BRIDGE REPLACEMENT - PPCB
NHSN-020-2(143)--2R-81

SAC COUNTY - DESIGN 116/216

EXAMPLE OF TITLE SHEET WITH 4 PLAN REVISIONS.

REVISION EXAMPLE

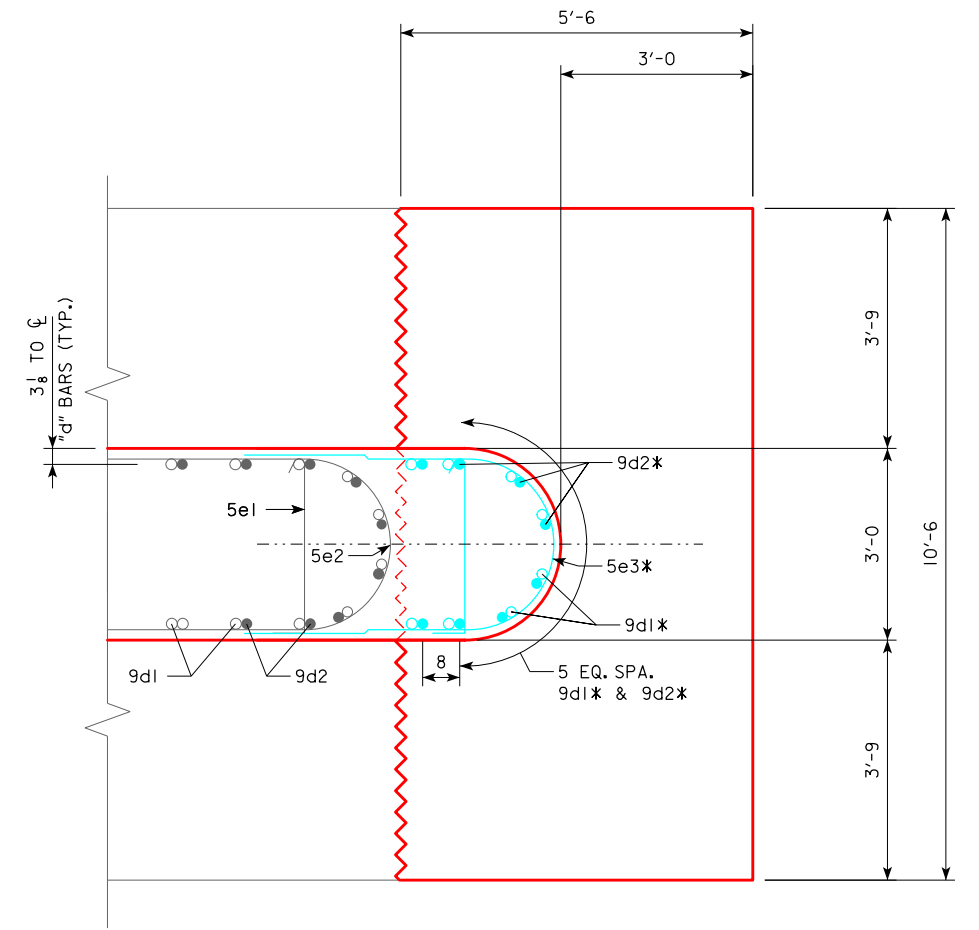
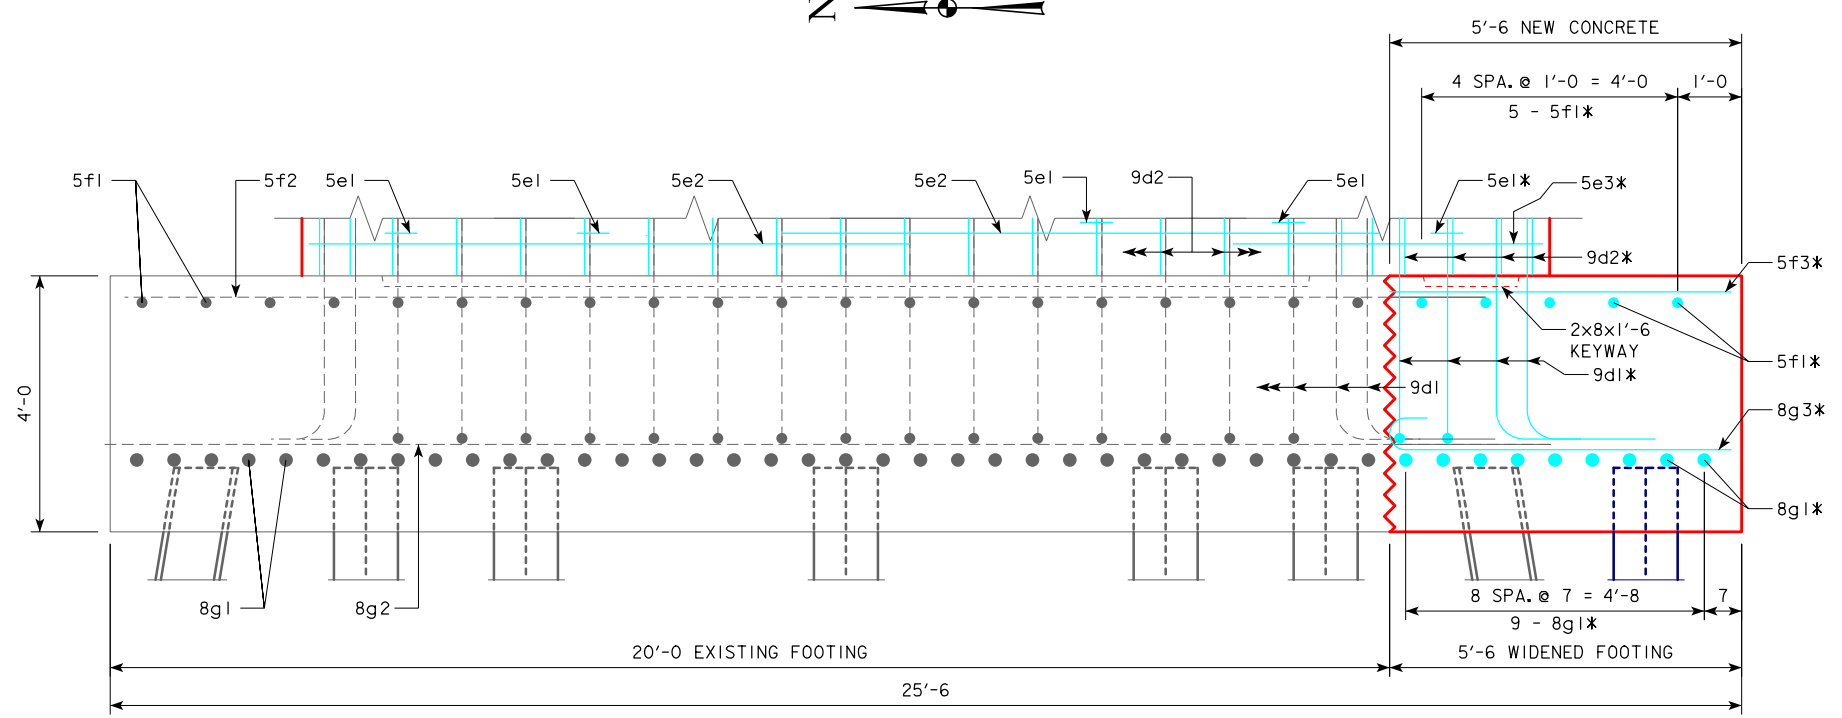
* NOTE:
ADDITIONAL REINFORCING BARS TO BE
PROVIDED. SEE DESIGN SHEET 9 FOR
UPDATED REINFORCING STEEL TABLE.

REVISION 1
REVISED: 03-09-2017 THIS SHEET ADDED, PIER 2
FOOTING DETAILS.
REASON: PIER 2 FOOTING MISPLACED 1.4 FT. NORTH
OF PLAN ALIGNMENT DUE TO CONSTRUCTION
SURVEY ERROR.

DESIGN SHEET NO. 7D OF 58 FILE NO. 30568 DESIGN NO. 116

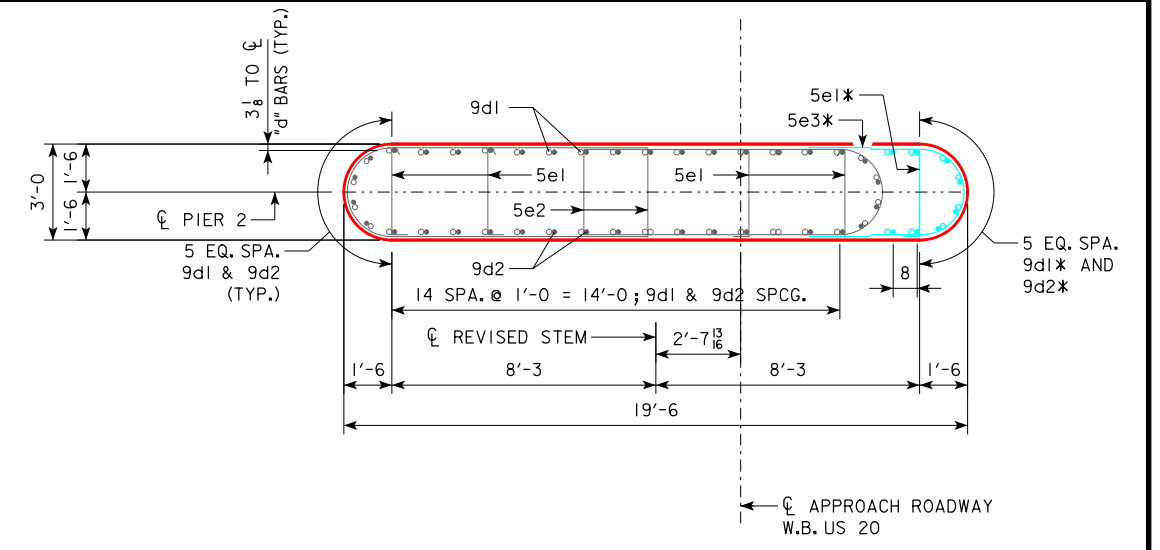
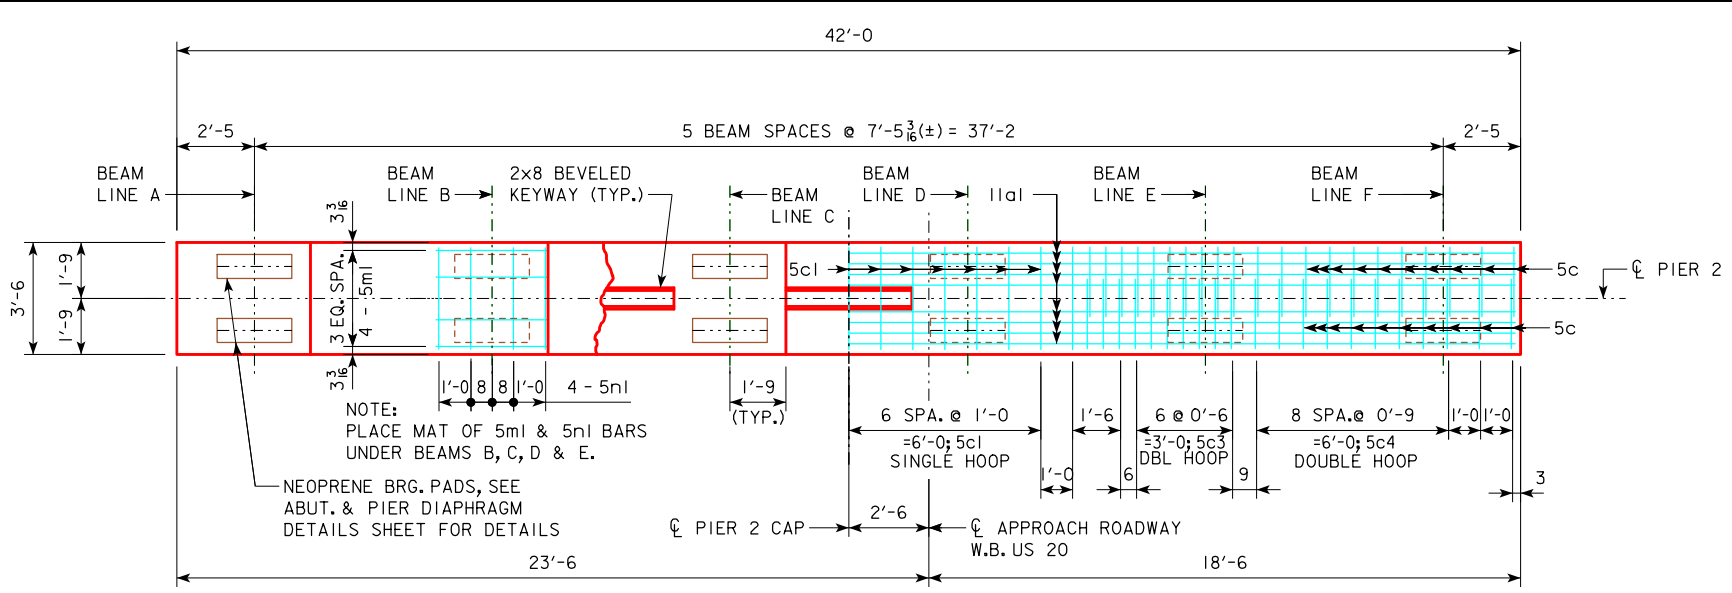
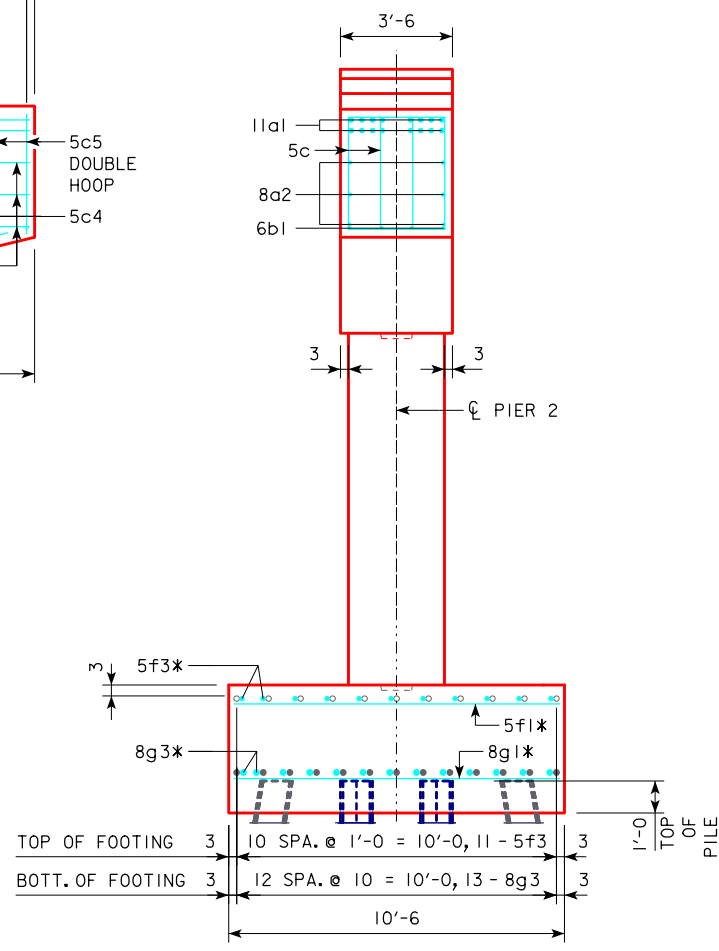
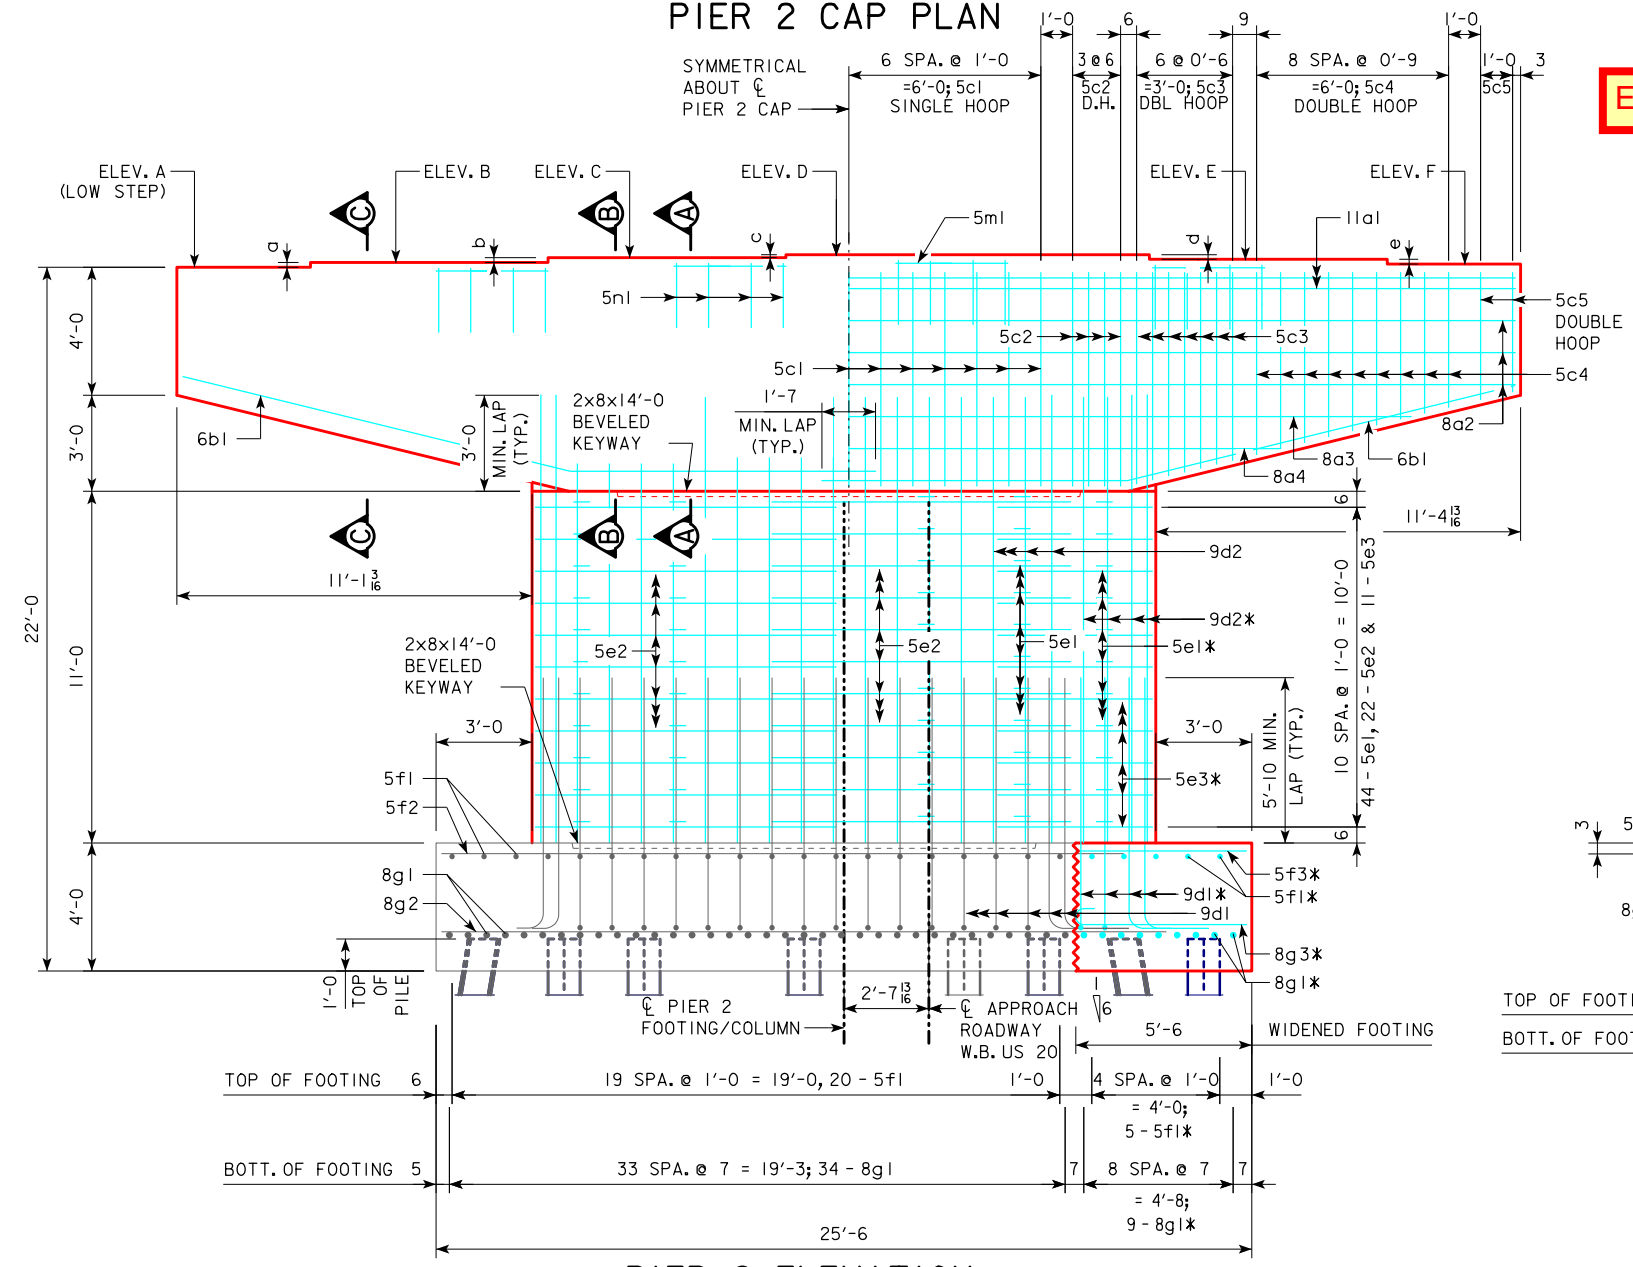
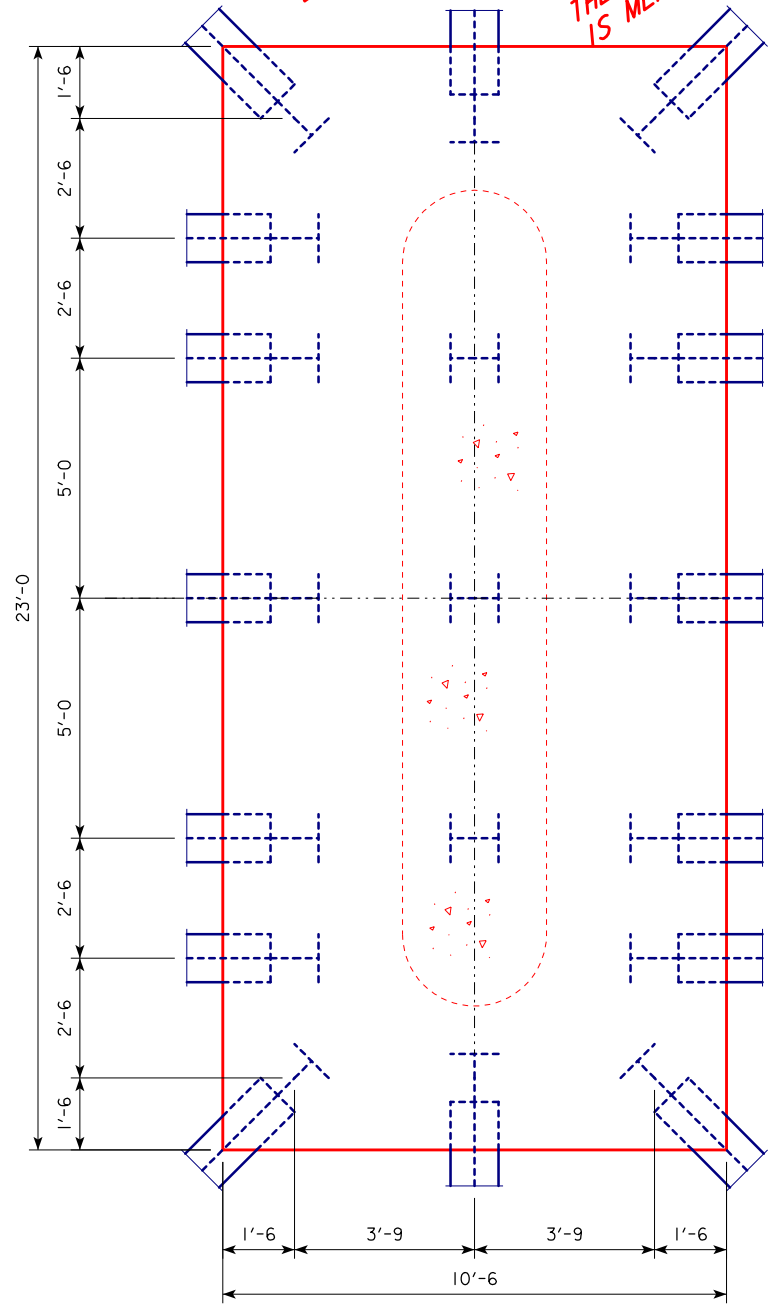
* NOTE: ADDITIONAL REINFORCING BARS TO BE PROVIDED. SEE DESIGN SHEET 9 FOR UPDATED REINFORCING STEEL TABLE.

REVISOR: 03-09-2017 THIS SHEET ADDED.

REASON: PIER 2 FOOTING MISPLACED 1.4 FT. NORTH OF PLAN ALIGNMENT DUE TO CONSTRUCTION SURVEY ERROR.

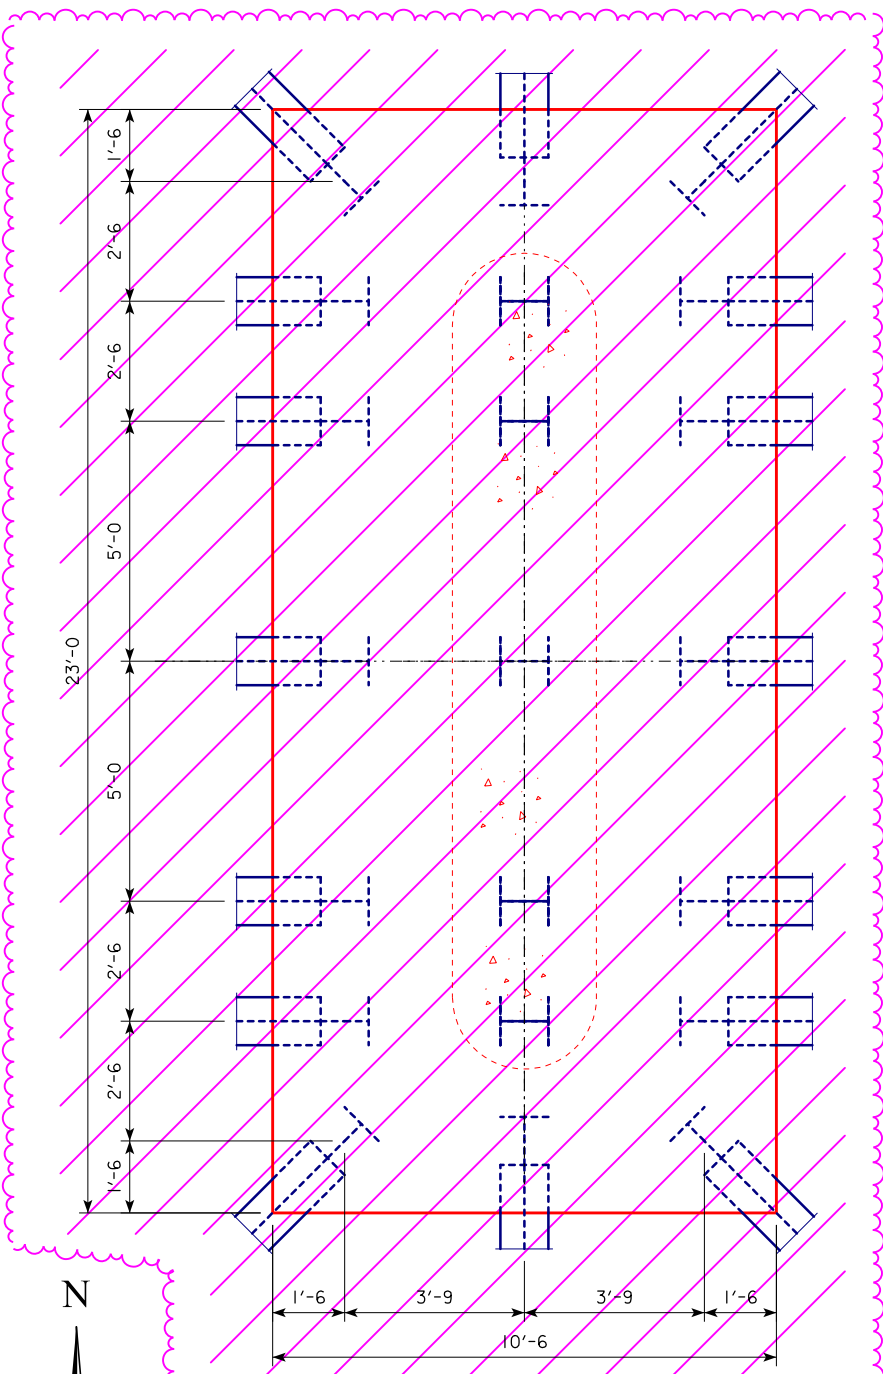
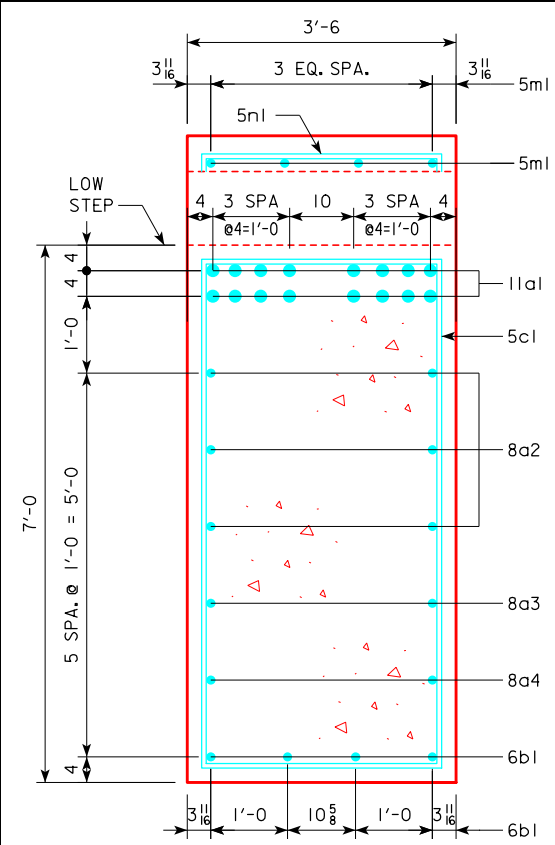
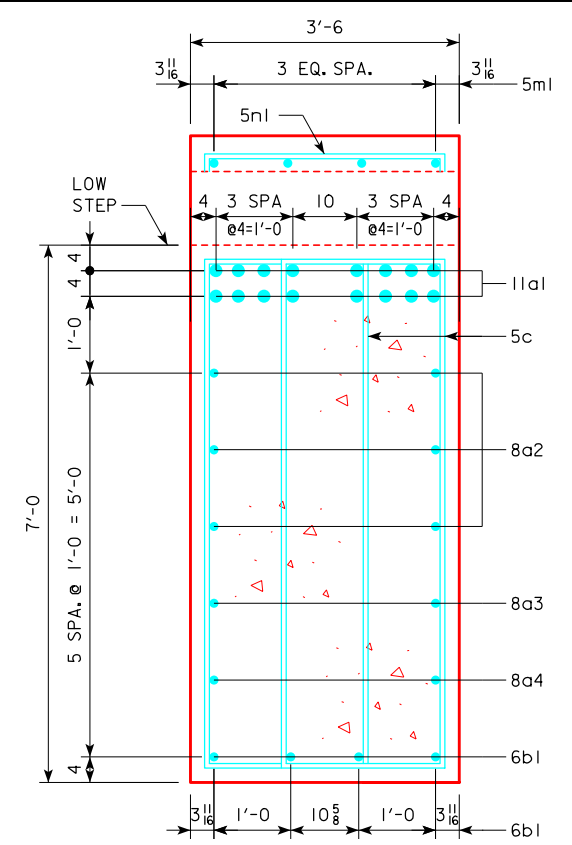
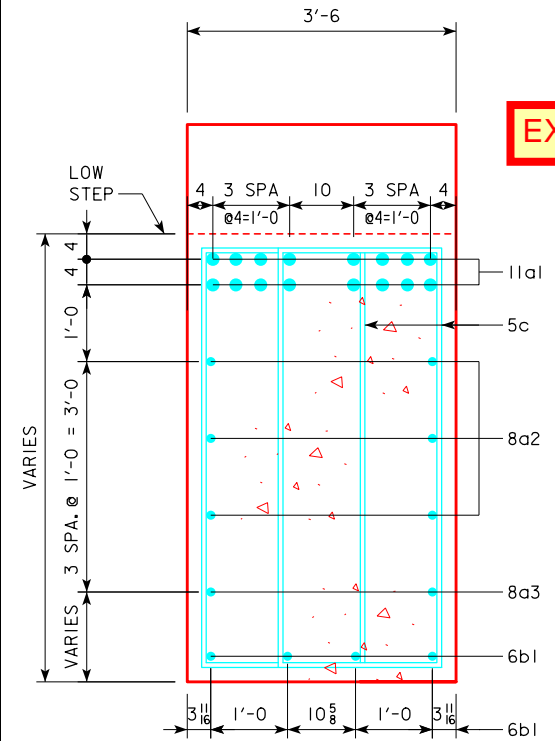
REVISOR: 03-09-2017 REMOVE PIER 2 FOOTING.
REASON: PIER 2 FOOTING MISPLACED 1.4 FT. NORTH
OF PLAN ALIGNMENT DUE TO CONSTRUCTION
SURVEY ERROR.

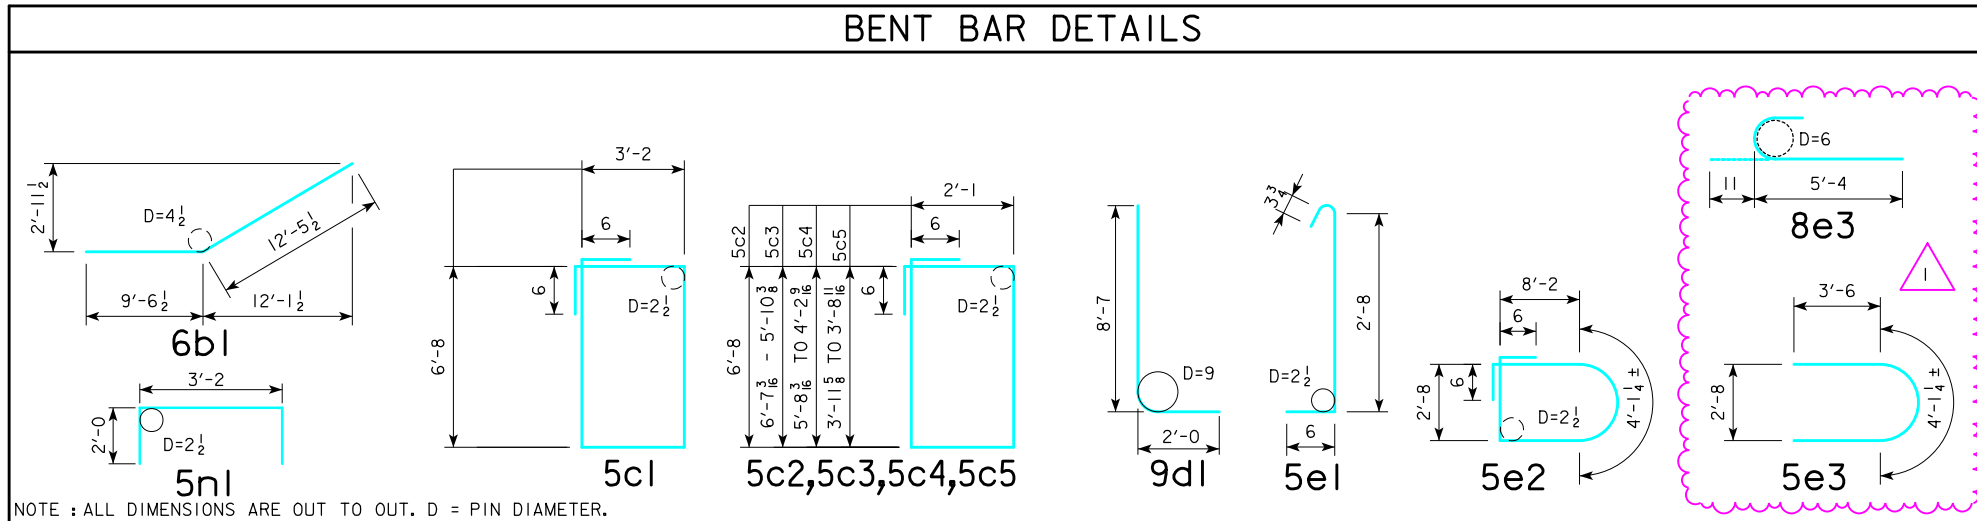
* NOTE:
ADDITIONAL REINFORCING BARS TO BE PROVIDED FOR WIDENED FOOTING. SEE DESIGN SHEETS 7C & 7D.

REVISION 1
REVISED: 03-09-2017 SEPARATED PIER 1 AND 2 QUANTITIES AND ADDED DOWEL NOTE.
REASON: PIER 2 FOOTING MISPLACED 1.4 FT. NORTH OF PLAN ALIGNMENT DUE TO CONSTRUCTION SURVEY ERROR.
